May 6, 2025

BYTEK VW Expansion Project
1325 St. Laurent Blvd.
Ottawa, Ontario
Our Ref: 2301

Post Tender Addendum N° 4

brian k. clark ARCHITECT	project BYTEK VW - RENOVATION 1325 ST. LAURENT BLVD.		scale: 1:100	date: 6 MAY 25	dwg. no.
	drawing		drawn by: DP	proj. no. 2301	ASK-5

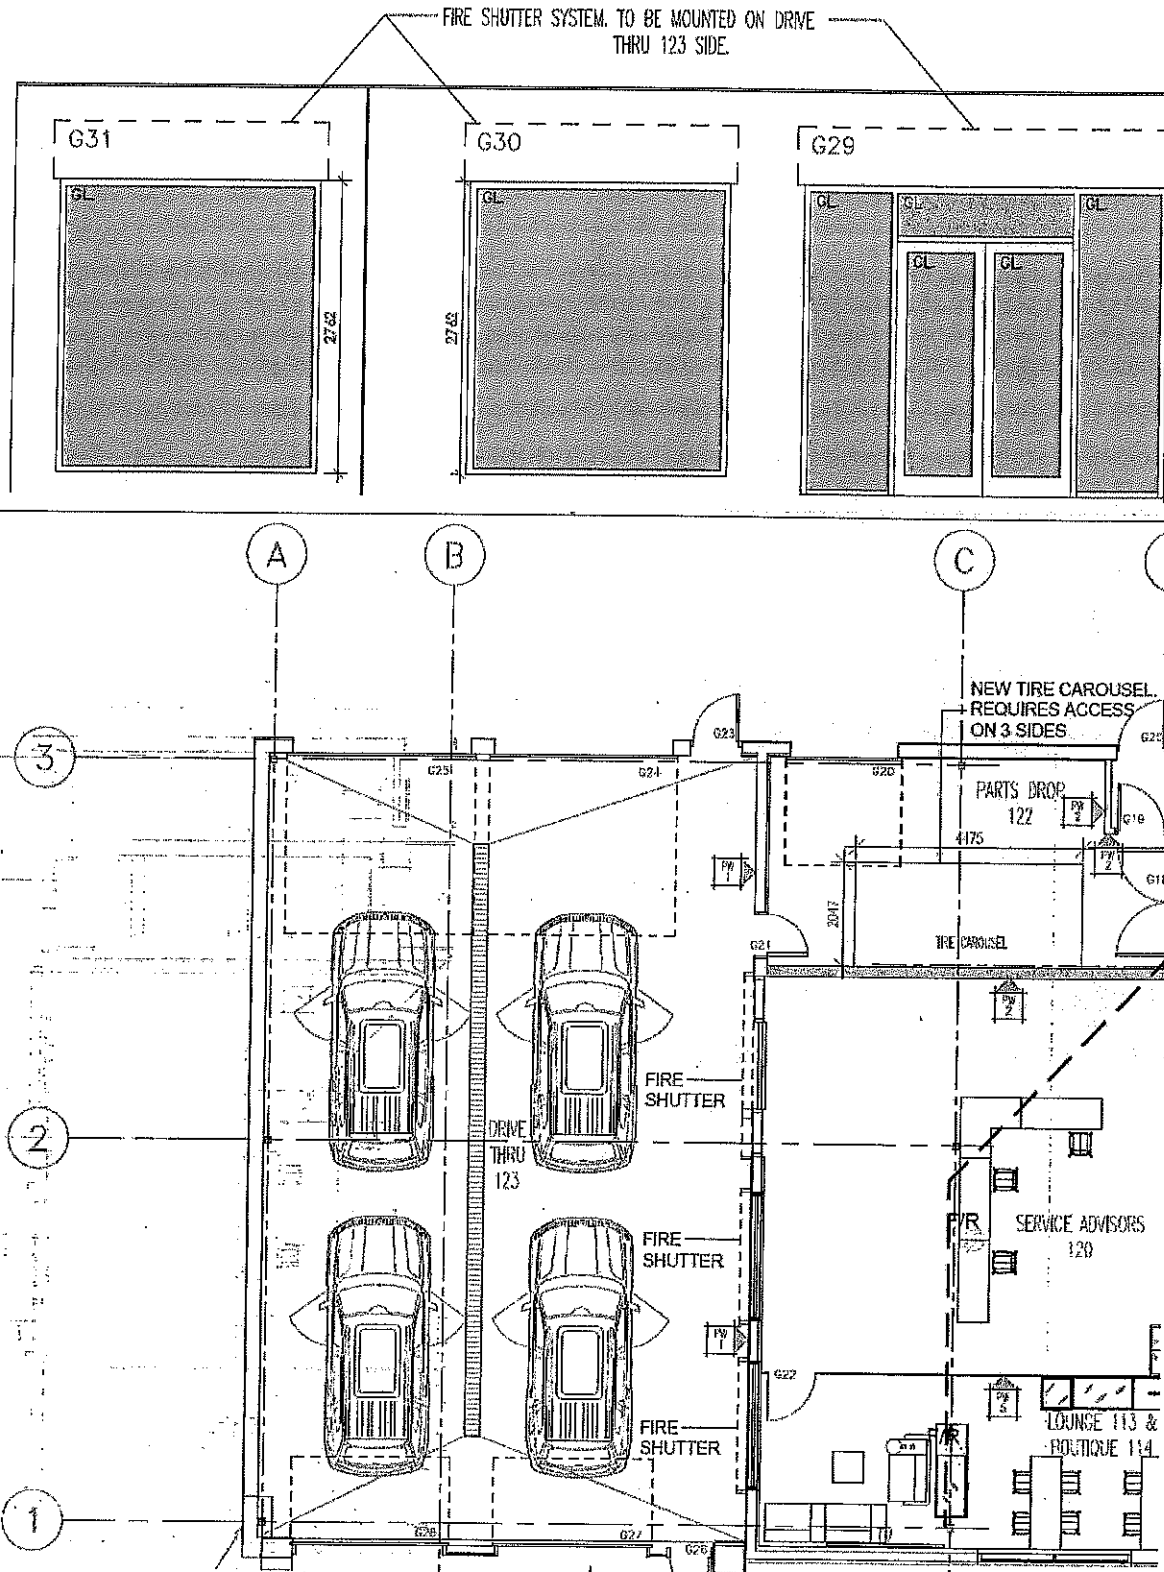
- 3.6 Drawing A-002,
Clarification notes added indicating extent of curtainwall and glazing to be removed. Refer to ASK-5.
- 3.7 Reference drawing ASK-6,
Notes added indicating extent of demolition and removal of partitions and floor as required to install all new underground plumbing and floor in basement. Refer to ASK-6.

dwg. no. ASK-6

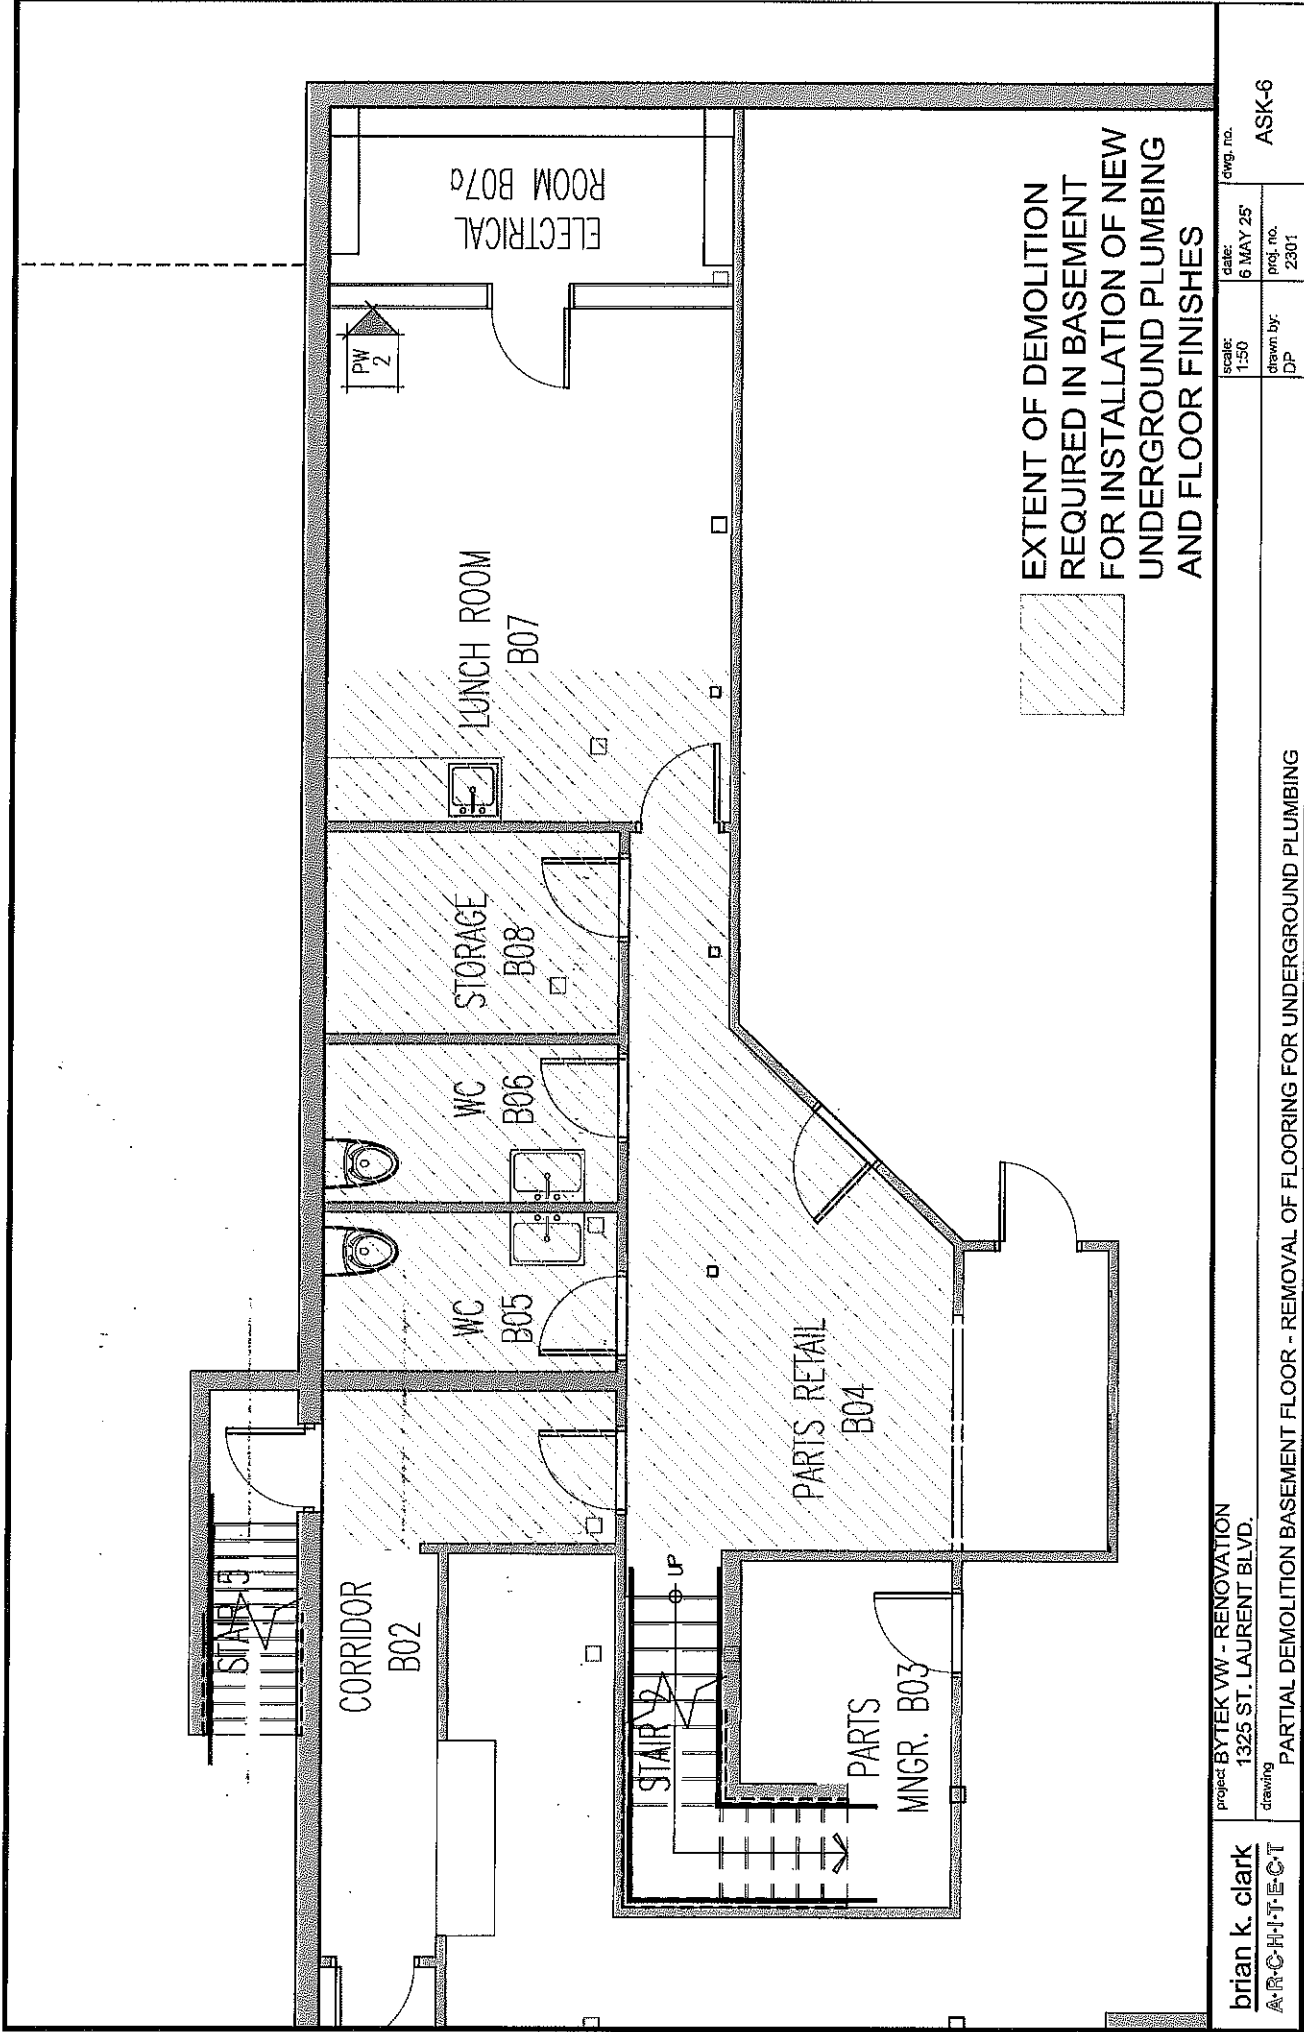
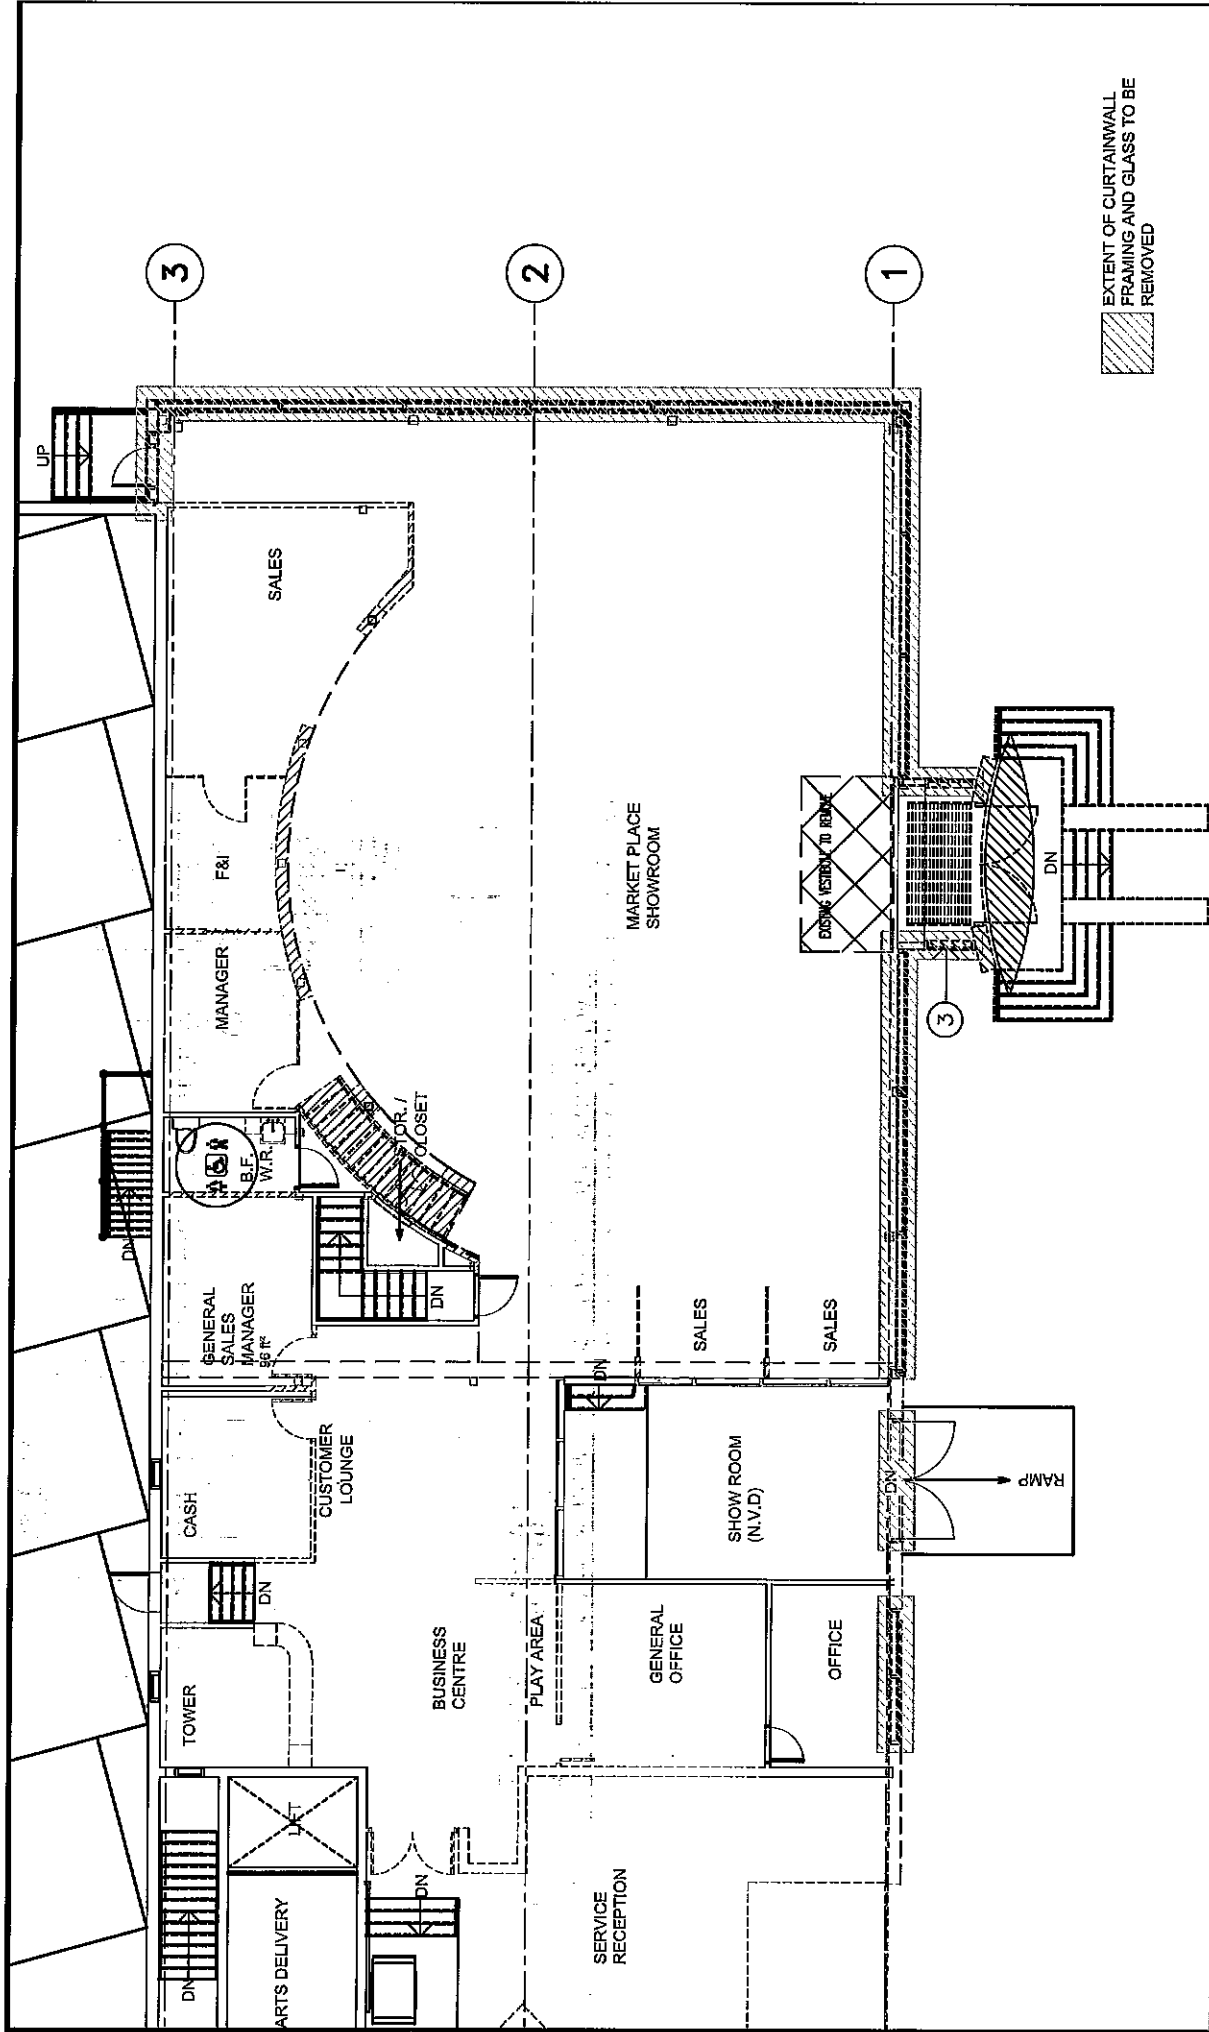
- 3.23 Ask-6 revised and re-issued
- 3.24 Reference Door No G29, Service Drive to Service Advisors
1 ½ HR FRR Shutter.
- 3.25 Reference Door No. G20 and G20a,
Clarify

PARTIAL DEMOLITION BASEMENT FLOOR - REMOVAL OF FLOORING FOR UNDERGROUND PLUMBING
